Service Bulletin N° 91

SUBJ: *TWISTER* Magnet Processor Board & Magnet Disc Motor Updates

BOARD UPDATE PROCEDURE:

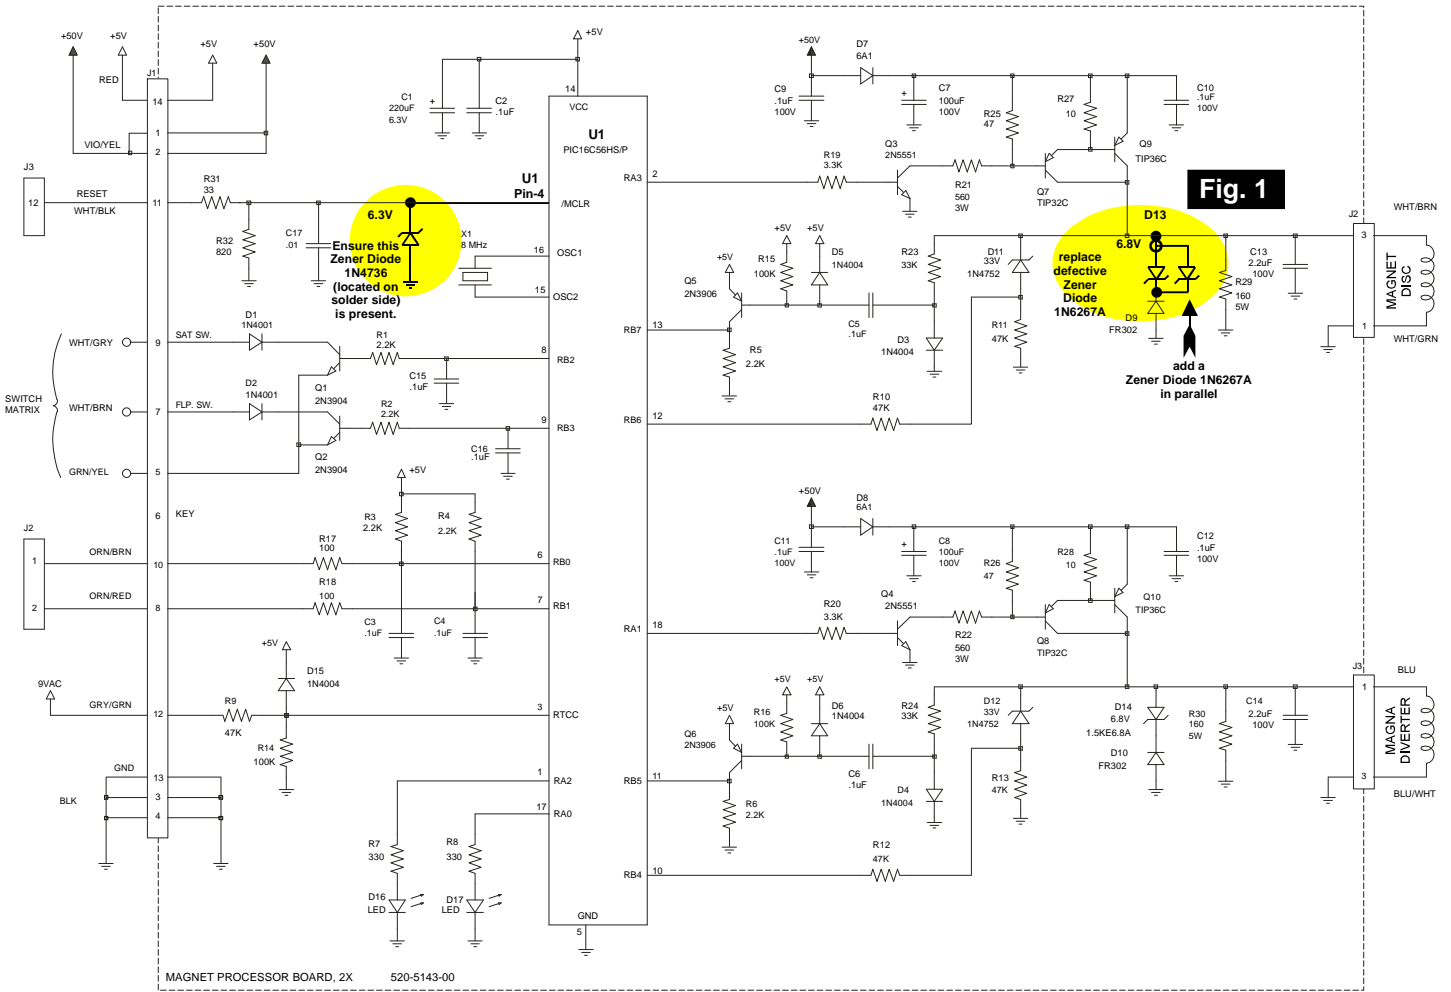
Replace the defective Zener Diode 1N6267A, Sega Part N° 112-5011-00, and add one in parallel at Loc. D13; Ref. Fig. 1 on the Magnet Processor / Driver Schematic *on the next page*.

MAGNET PROCESSOR SCHEMATIC

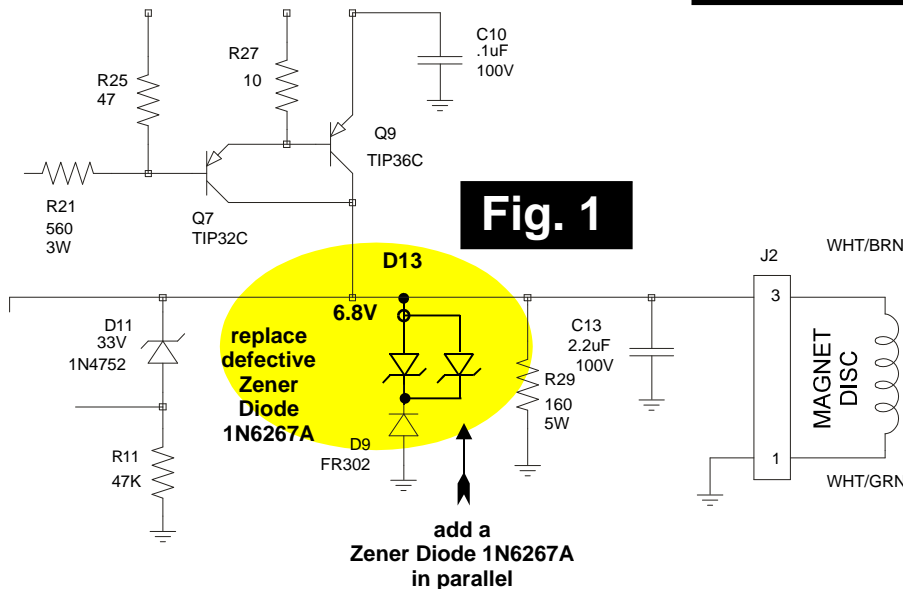
Please Note: Update your Manual Schematic, Section 5, Chapter 2, Page 90: As shown above, J2 should be Magnet Disc, and J3 should be Magnet Diverter. The manual referenced them the other way around.

MAGNET DISC MOTOR DRAWING

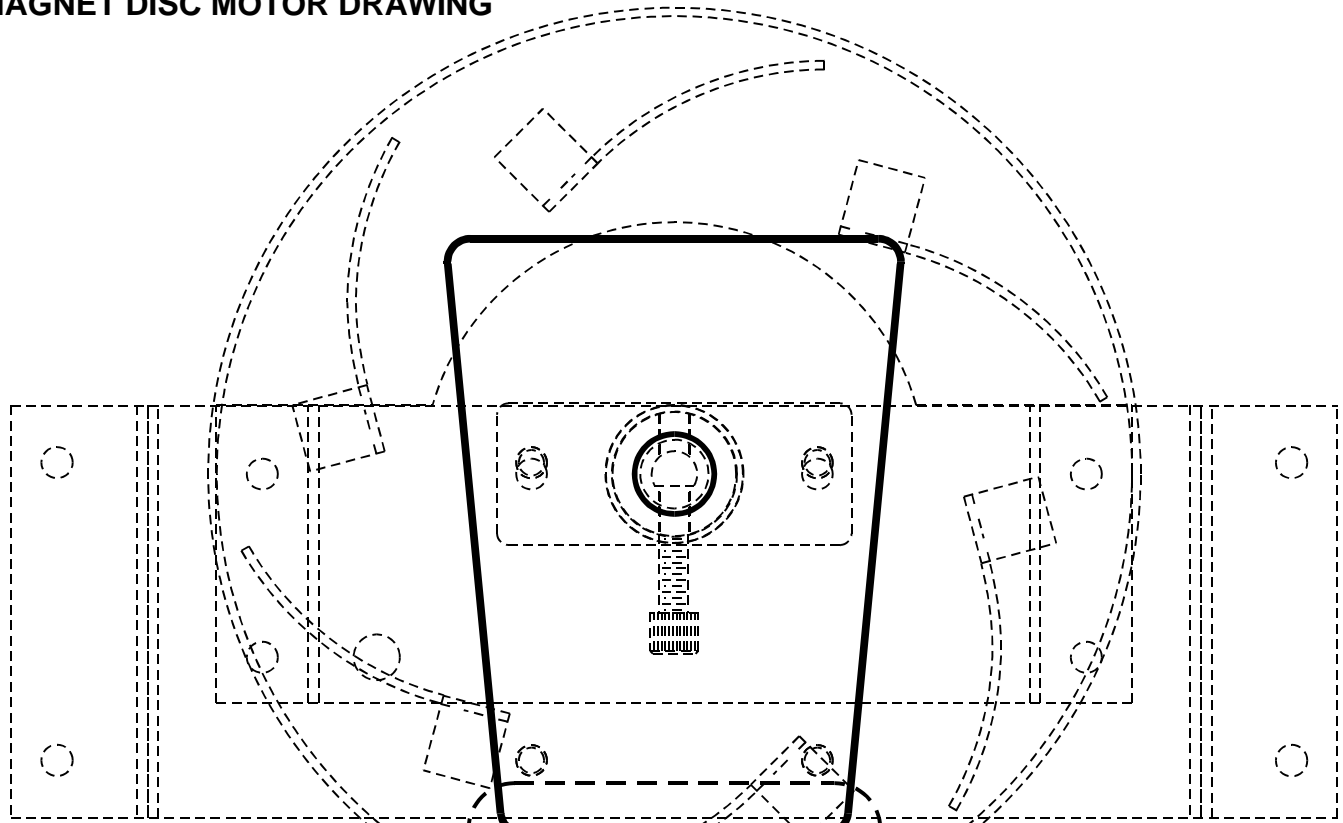
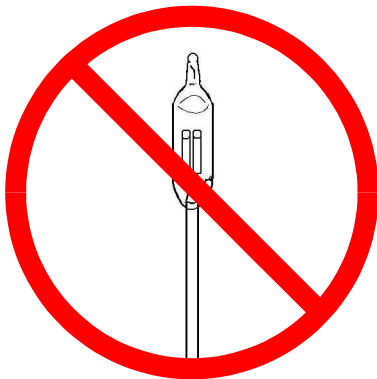
1. Remove the Neon Bulb from the Magnet Disc Motor Connector.
2. Add a 22Ω 1/2 watt resistor, Sega Part N° 121-5040-00, in series with the Disc Motor TI 2.2J 205VDC/160VAC Capacitor (Sega Part N° 125-5002-00) located at the harness connector. Refer to the Magnet Disc Motor Drawing on page 3.

Remove the Neon Bulb
from the Magnet Disc Motor
Connector by clipping the leads.

This connector should have
this large yellow capacitor, not the
small "disc" shape .01 Capacitor.

After removal of the Neon Bulb, add
this resistor in series with the Capacitor.
